SUBDIVISION REVIEW SHEET

<u>CASE NO.</u>: C8-95-0208.03 <u>Z.A.P. DATE</u>: 1-5-16

SUBDIVISION NAME: Metrotech Preliminary Plan - Revision #3

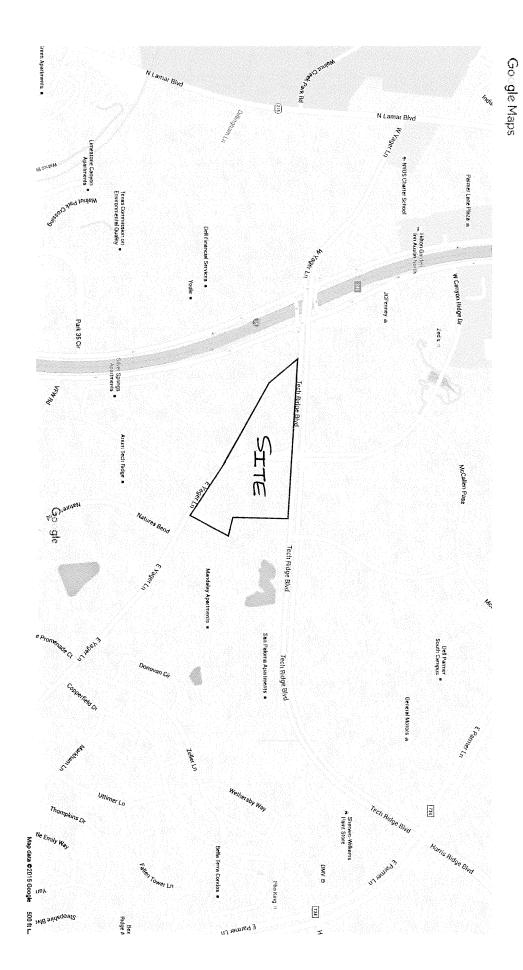
STAFF RECOMMENDATION: The staff recommends disapproval of the plat. This plat does not meet all applicable State and City of Austin LDC requirements.
